FALCON HIGHLANDS FILING #3 PUD/PRELIMINARY PLAN

April 2022

WASTEWATER DISPOSAL REPORT

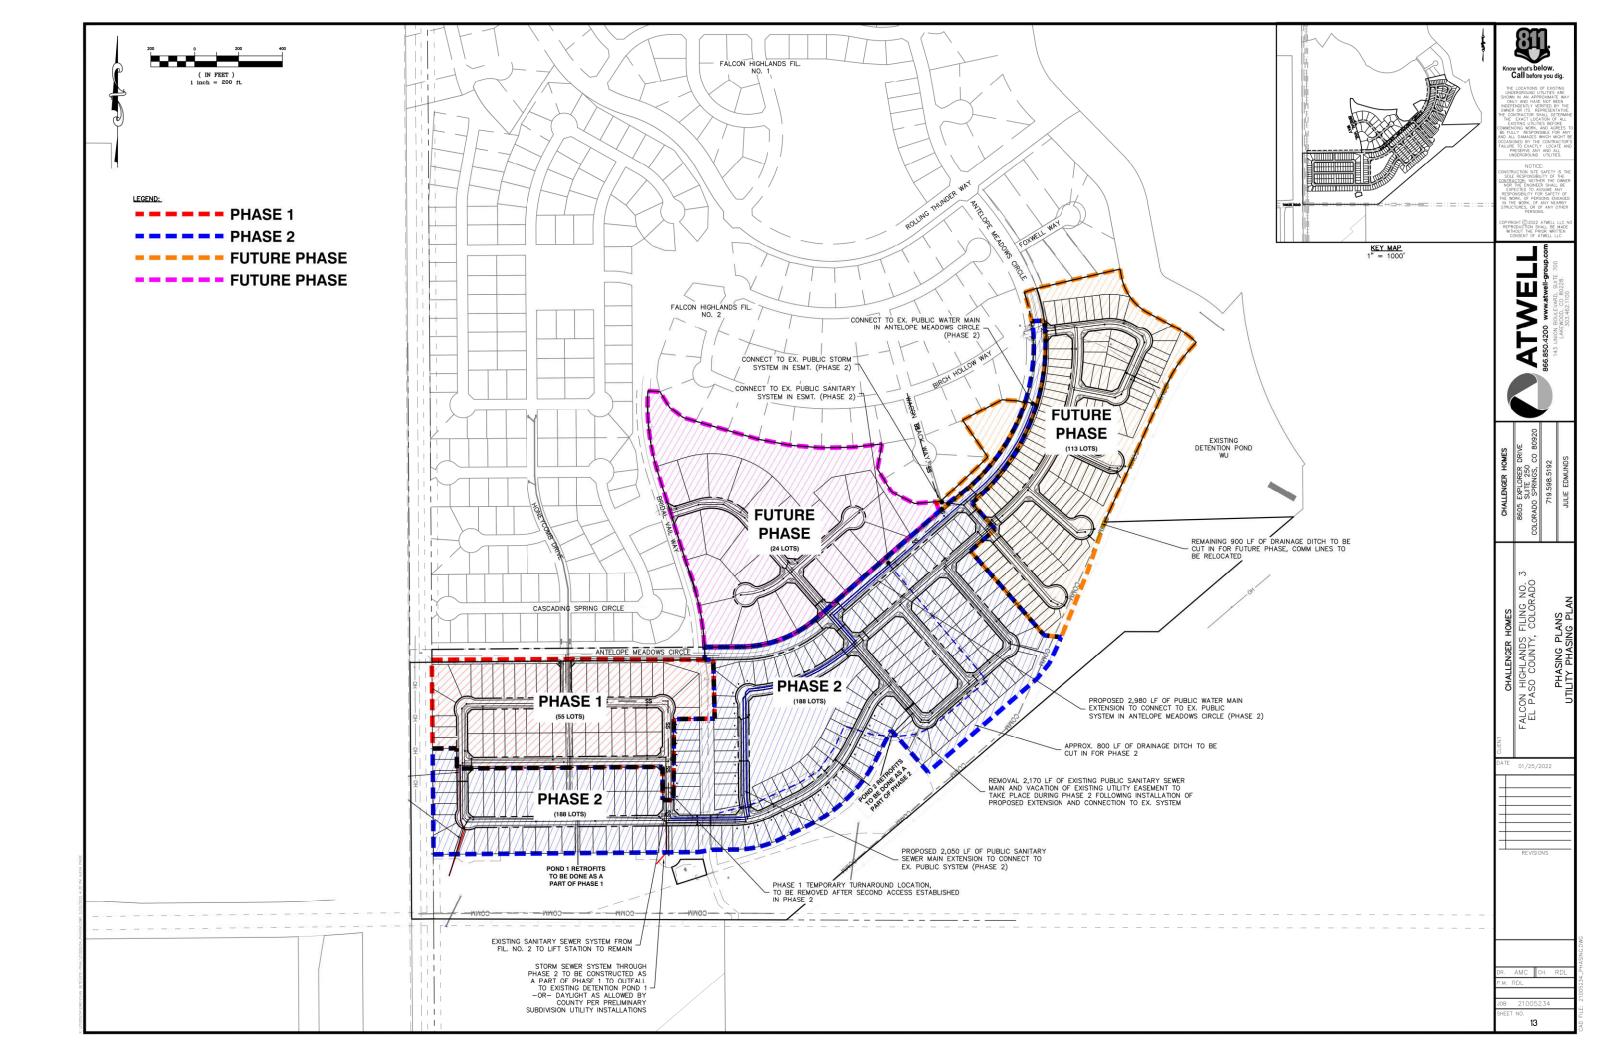
As mentioned above, this development will require upgrades to the existing lift station, as well as force main modifications – both will trigger an amendment to the existing IGA. *** 1 1

> Please identify specifically how many units can be built before these improvements are triggered. It appears that 300 units can be added to the current system but it is not clear why or which improvement will trigger the amendment to IGA first. This will need to be a condition of approval for the PUDSP and will need to be worked out prior to public hearing.
